Subdivision Bylaw Amendment Public Hearing

Planning & Development Department

Overview of Amendments

MUNICIPAL PLANNING STRATEGY Transportation Map, Map #2

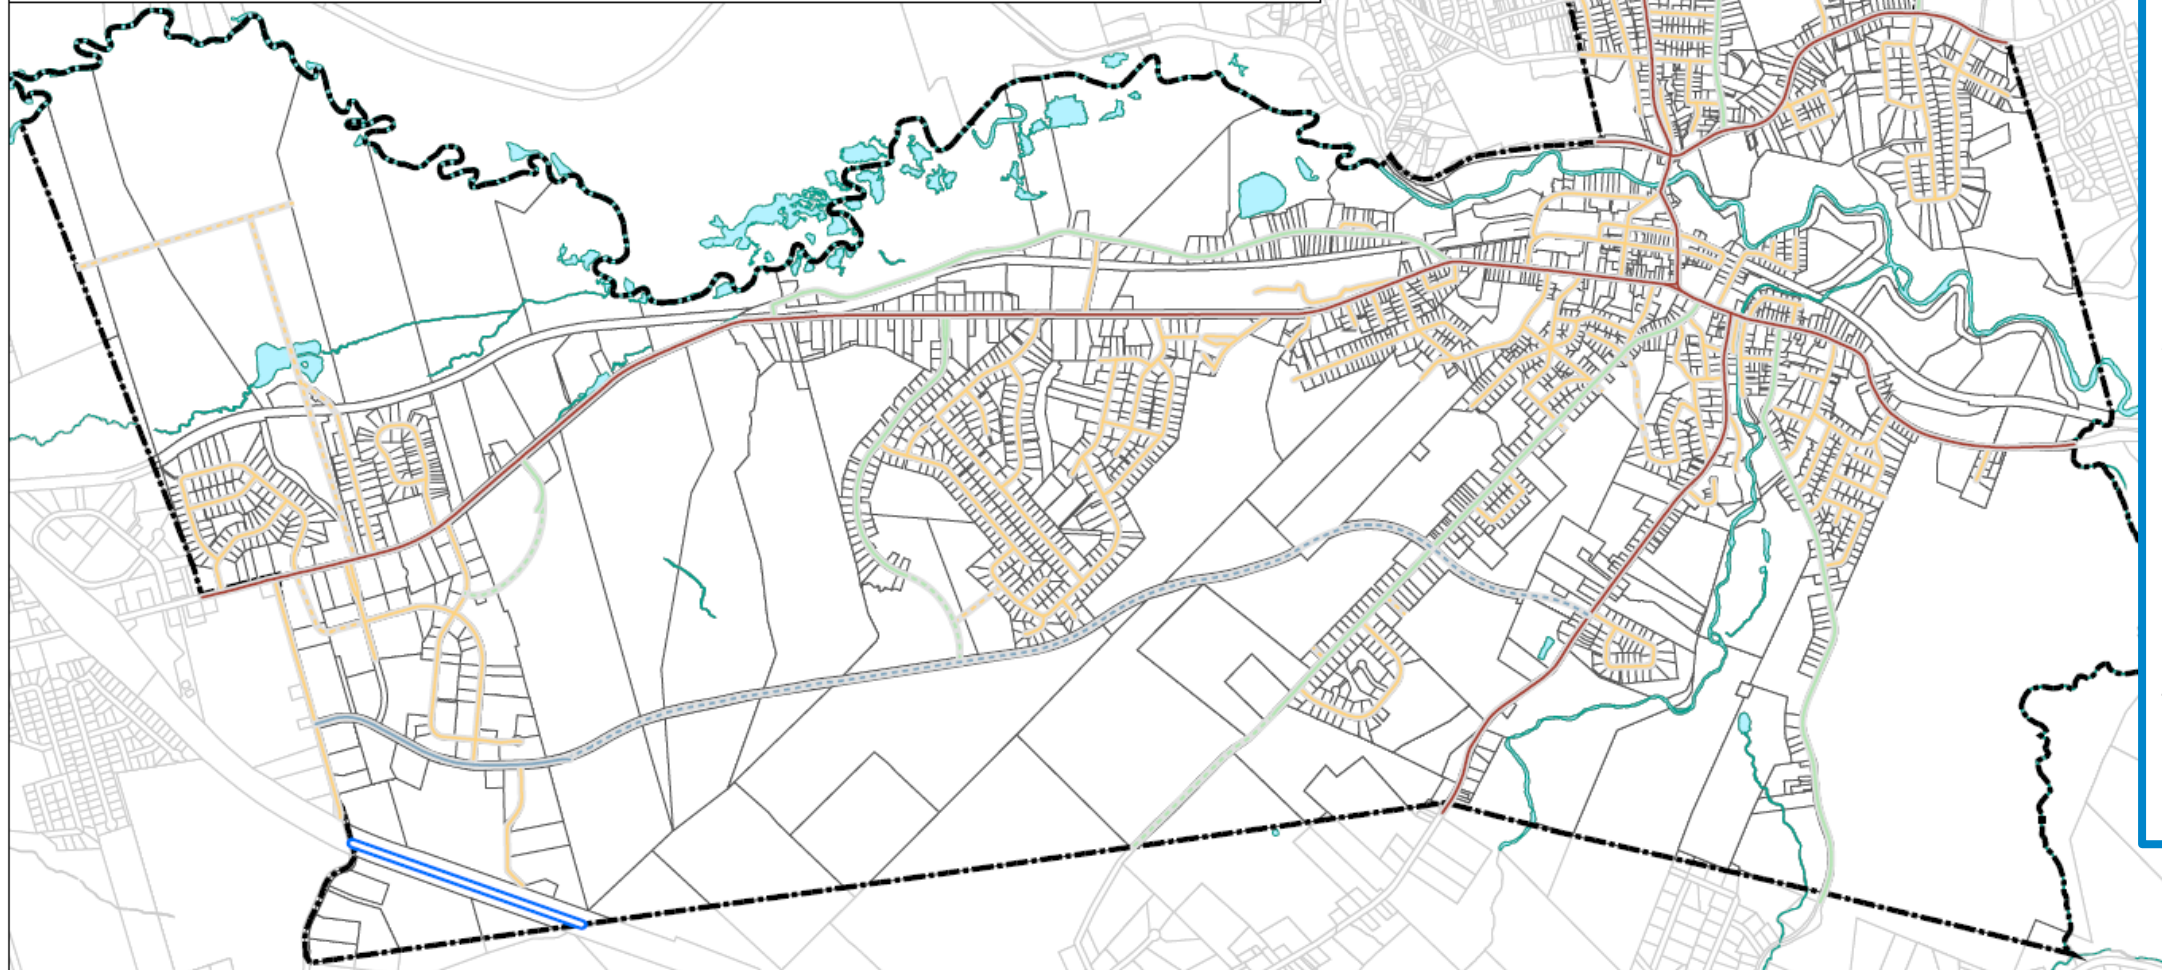
- In 2008, the Bylaw was amended to remove the requirement for sidewalks to be built on collector roads.

Arterial Roadways - Both Sides **(Amended January 2008)**

2.12 Sidewalks **or Multi-Use Pathways** shall be incorporated into the construction of new **collector and** arterial roadways as per the following:

Arterial Roadways – **Sidewalks on Both Sides or Multi-Use Pathway on One Side**

Collector Roadways – **Sidewalk or Multi-Use Pathway on One Side**
